ALERT SERVICE BULLETIN

214-12-73
25 May 2012

MODEL AFFECTED: 214B/B-1

SUBJECT: MAIN ROTOR HUB ASSEMBLY SPINDLE ASSEMBLY, P/N 214-010-103, MANDATORY INSPECTION AND OVERHAUL REQUIREMENTS.

Figure 65-7. Main Rotor Hub Conditional Inspection (Sheet 4 of 6)

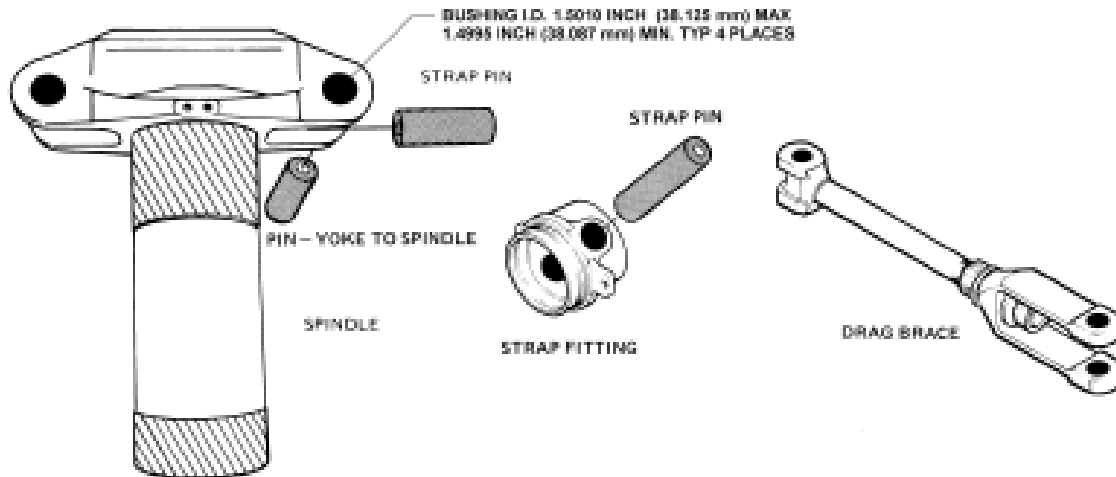
2. Figure 65-7 (sheet 4)

See page 6 of this bulletin.

NO.	ITEM	REUSE SPINDLE	SCRAP SPINDLE-STRAPS-PINS	SCRAP HUB ASSY
	NOMENCLATURE			
1	Spindle lug faces, eight places	No visible deformation on lug face when checked with a straight edge	Any visible deformation on both sides of a lug when checked with a straight edge	
2	Spindle to yoke attachment bushings	Unworn 214-040-129 pin shall fit through the spindle tangs without interference. Hole round within 0.0005 inch.	Any significant bind or looseness. Out-of-round exceeds 0.0005 inch.	
3	Strap Pin Hole	Hole round within 0.0005 inch.	Out-of-round exceeds 0.0005 inch.	Out-of-round exceeds 0.0015 inch with larger dimension in a spanwise direction.

Figure 65-8. Main Rotor Hub Mechanical and Corrosion Damage Limits (Sheet 2 of 7)

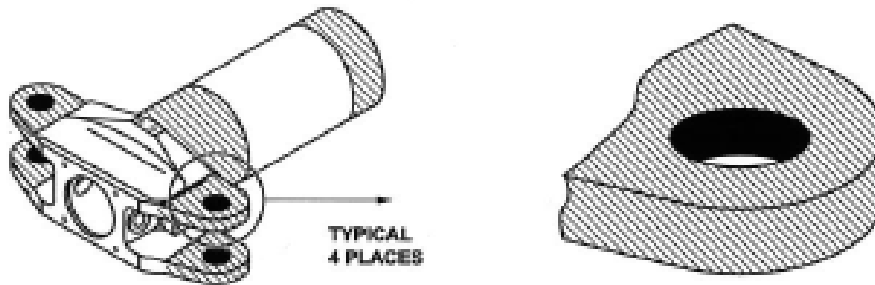
3. Figure 65-8 (sheet 2)

See page 7 of this bulletin.

TYPE OF DAMAGE	MAXIMUM DEPTHS AND REPAIR AREAS		
	0.001 Inch (0.0254 mm)	0.010 Inch (0.254 mm)	0.004 (0.1016 mm)
MECHANICAL DAMAGE	0.001 Inch (0.0254 mm)	0.010 Inch (0.254 mm)	0.004 (0.1016 mm)
CORROSION DAMAGE	0.001 Inch (0.0254 mm)	0.010 Inch (0.254 mm)	0.004 (0.1016 mm)
MAXIMUM AREA PER FULL DEPTH REPAIR	0.50 Inch Square (322.88 mm sq)	Not Critical	0.50 Inch Square (322.88 mm sq)
NUMBER OF REPAIRS	Two	Not Critical	Two Per Shaded Area
EDGE CHAMFER	0.010 Inch (0.254 mm)	0.040 Inch (1.016 mm)	0.010 Inch (0.254 mm)
MOUNT BOLT BORE DAMAGE:	0.001 Inch for 1/4 of Circumference, size limits apply.		
CRACKS:	No cracks allowed.

Figure 65-8. Main Rotor Hub Mechanical and Corrosion Damage Limits (Sheet 3 of 7)

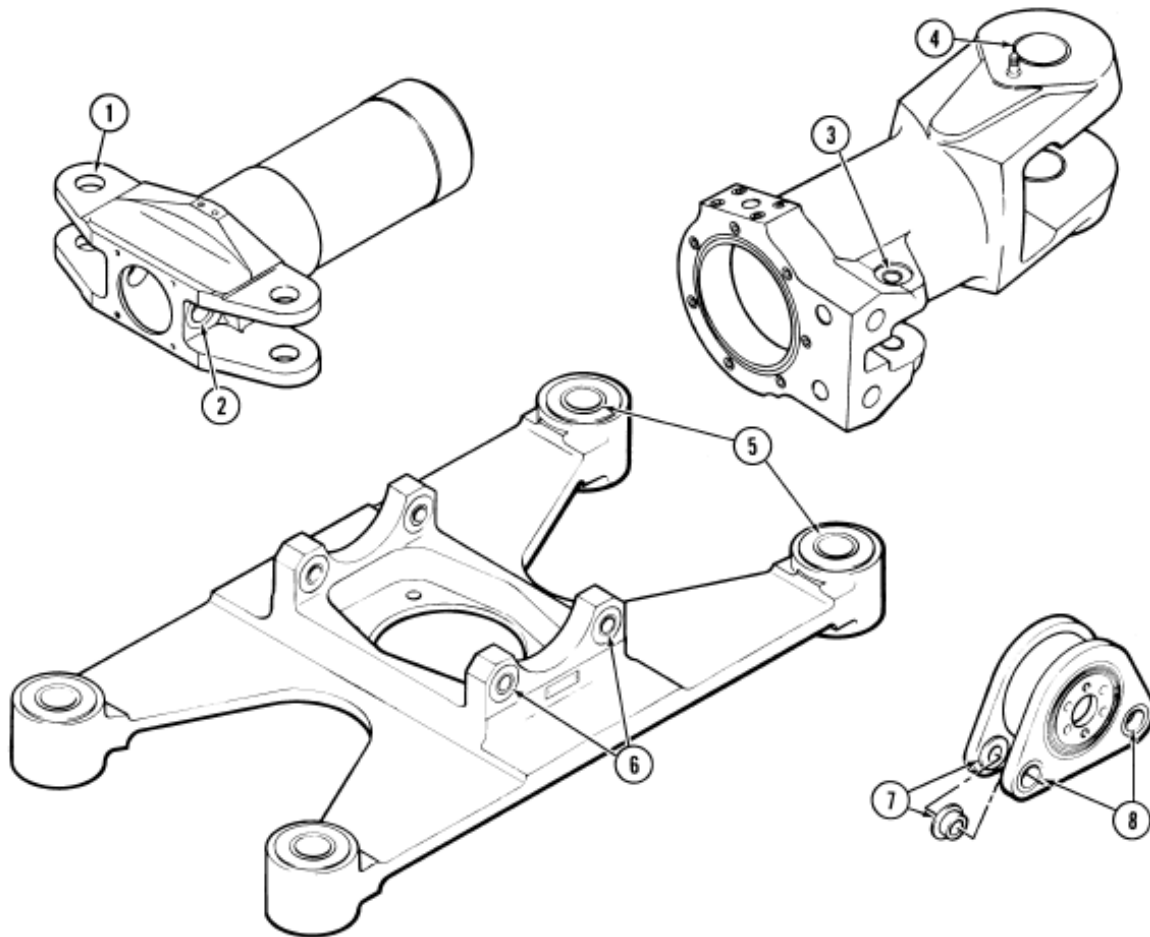
4. Figure 65-8 (sheet 3)

See page 8 of this bulletin.

MECHANICAL DAMAGE	0.010 INCH (0.254 mm)	0.004 INCH (0.1016 mm)
CORROSION DAMAGE	0.010 INCH (0.254 mm)	0.004 INCH (0.1016 mm)
MAXIMUM AREA PER FULL DEPTH REPAIR	NOT CRITICAL	0.50 SQ. INCH (322.588 sq. mm)
NUMBER OF REPAIRS	NOT CRITICAL	TWO PER SHADED AREA
EDGE CHAMFER	0.040 INCH (1.016 mm)	0.010 INCH (0.254 mm)
BUSHING BORE DAMAGE: ● DAMAGE MAY BE WORKED TO DIMENSIONS SHOWN BELOW ONLY.		
BORE DIAMETER		
(BUSHING REMOVED) - STANDARD 1.6875 to 1.6980 INCH (42.862 to 42.875 mm)  		
- OVERSIZE 1.7075 to 1.7180 INCH (43.376 to 43.383 mm)		
CRACKS:	NO CRACKS ALLOWED

-  Measured twice (90° apart) at top and bottom of each hole.
-  Typical 4 places.
